**ADDENDUM #3**  
**October 25, 2021**

**PROJECT:**     *Center Elementary School Entrance Improvements*

**OWNER:**     City of Waycross

## EXPANSION SPLICE #ES-1

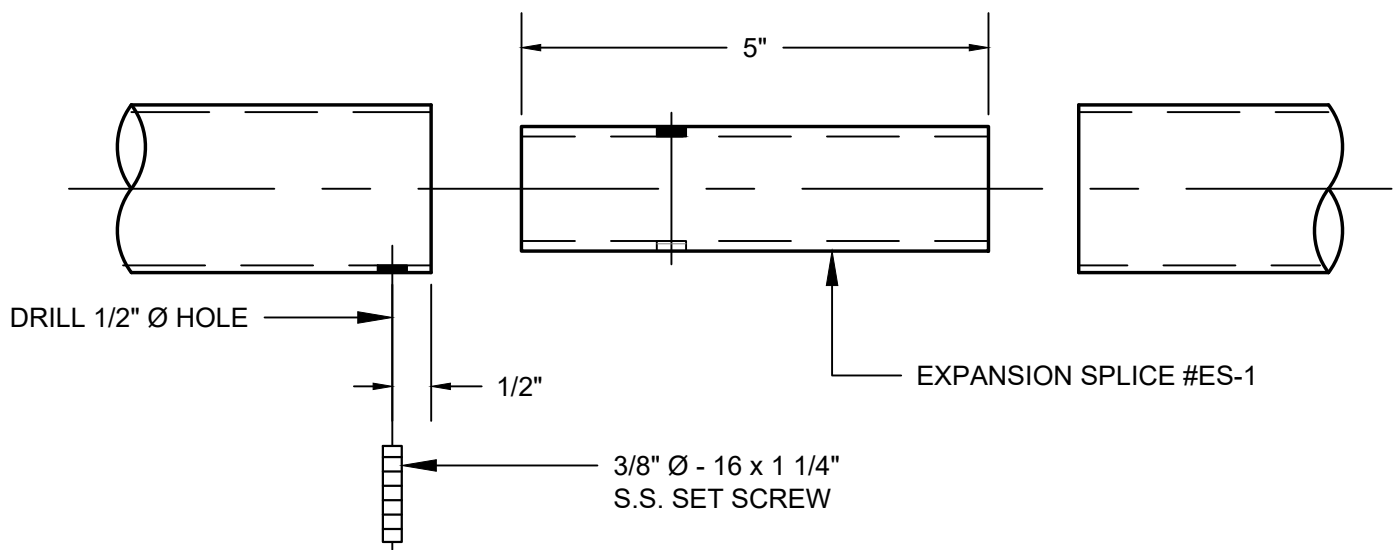
- a.    Handrail expansion joint splices shall be ES-1 by Thompson Fabricating, or equal.  
      See attached for detail of handrail expansion joint.
